Access Compliance Report

Public Rights-of-Way

(Curb Ramps)

Intersection ID: 51323	Main Street: GLENMORE_GARDEN_DR	Cross Street: MCKEE_RD	Location: SE
ADA ID: 4ECF74B74830	Ramp Type: Perp	Initial Pass/Fail: Fail	Overall Compliance: No
Codes/Mitigation Info/Possible Solution			Severity Score: 22.5
			Field Measurements/Component Compliance

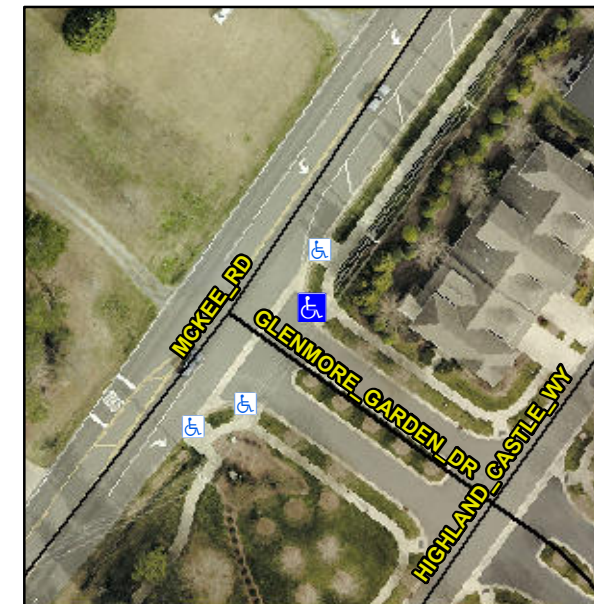
R304.5.1, R304.2.2, R304.5.3

Compliance	Description	Data	Compliance	Description	Data
N/A	Ramp Length (in)	97.0	No	Ramp Slope (%)	8.7
No	Ramp Width (in)	46.0	No	Ramp XSlope (%)	2.6
N/A	Flare Type LT	N/A	N/A	Flare Type RT	N/A
N/A	Flare Slope LT (%)	N/A	N/A	Flare Slope RT (%)	N/A
N/A	Flare Traversable LT?	N/A	N/A	Flare Traversable RT?	N/A
N/A	Landing Length (in)	N/A	N/A	DWS Provided?	N/A
N/A	Landing Width (in)	N/A	N/A	DWS Contrast?	N/A
N/A	Landing Slope (%)	N/A	N/A	DWS Length (in)	N/A
N/A	Landing X Slope (%)	N/A	N/A	DWS Full Width?	N/A
N/A	Landing Curb? (Y/N)	N/A	N/A	DWS Offset (in)	N/A
N/A	Shared Landing?	N/A			
N/A	Gutter Ponding?	N/A	N/A	Gutter Slope (%)	N/A
N/A	Gutter Lip Ht (in)	N/A	N/A	Gutter X Slope (%)	N/A
N/A	Painted X Walk1?	No	N/A	Painted X Walk2?	N/A
	X Walk 1 Direction	To SW		X Walk 2 Direction	N/A
N/A	X Walk 1 Width (in)	N/A	N/A	X Walk 2 Width (in)	N/A
	X Walk 1 Slope (%)	0.8		X Walk 2 Slope (%)	N/A
	X Walk 1 X Slope (%)	3.1		X Walk 2 X Slope (%)	N/A

Remove & Replace Entire Ramp.
